THE PORT AUTHORITY OF NY & NJ

ADDENDUM #3

**TO PROSPECTIVE BIDDER(S) ON CONTRACT # WTCR – W30-2011-31
WTC REDEVELOPMENT – WTC TOWER 2 PLAZA INTERIM IMPROVEMENTS**

SK-4
 SCALE: 3" = 1'-0"
 MPFP
 2-10-15

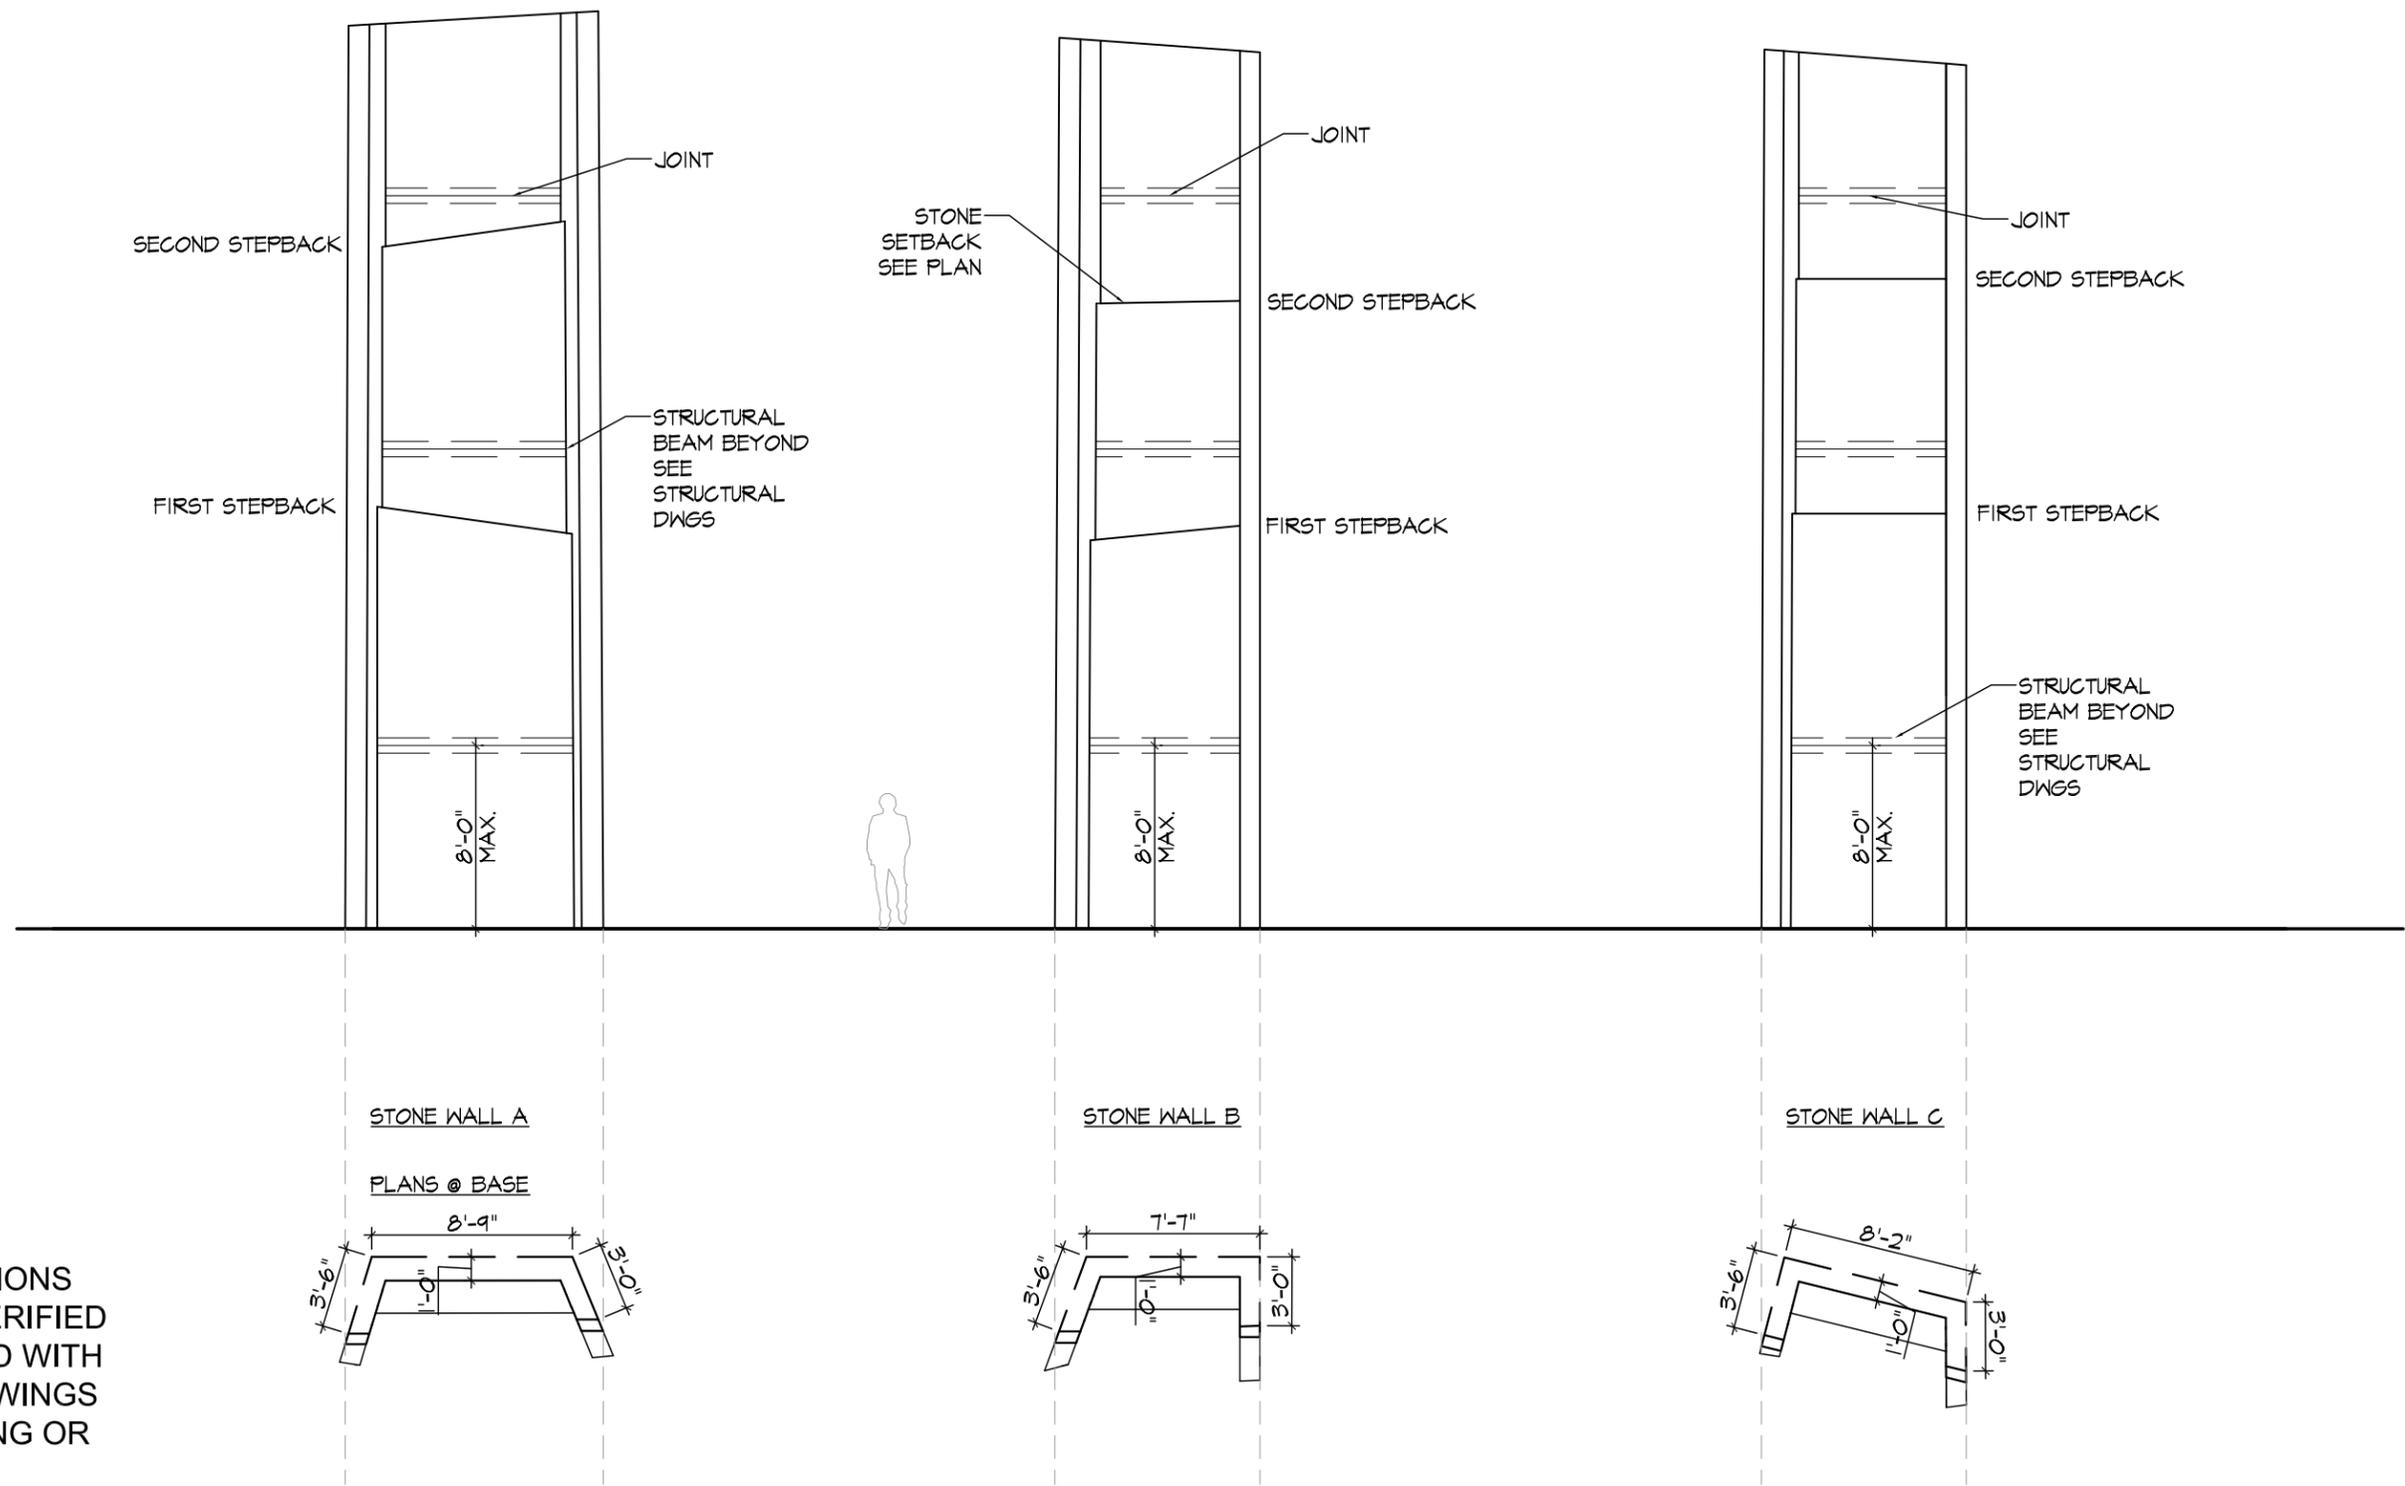
Answer #61	Assume stone panels are 4’ long.
Question #62	Drawing L-600, detail 10 LIGHT CHANNEL DETAIL shows the BLUESTONE SLAB in front of the light channel and the STONE WALL behind the light channel. But the encircled enlargement to the left side of the detail show the 2” VENEER. Is there a better detail for these 3 setback stone wall areas?

Question #70	Sheet L-601 – Please provide additional detail regarding the stone work.
Answer #70	Please refer to SK-4 and SK-5 dated 2/10/15, as well as SK-11 and SK-12 dated 2/13/15 for additional sections and dimensions.

Question #71	Sheet L-601 – Please provide a section through the curb showing how the stone ties into the curb and wall at that joint.
Answer #71	Please refer to SK-4 and SK-5 dated 2/10/15, as well as SK-11 and SK-12 dated 2/13/15 for additional sections and dimensions.

Answer #62	Enlargement is meant to show construction of stone channel only. For construction of stone wall see L-601 and SK-4 dated 2/10/15.
Question #63	Drawing L-600 at “2 BENCH DETAIL” on the left hand side the encircled enlargement calls for “5 SIDES OF TROUGH FINISHED WITH STONE”. “10 LIGHT CHANNEL DETAIL” says the same. We see 3 sides, are the other 2 sides the “ends”?
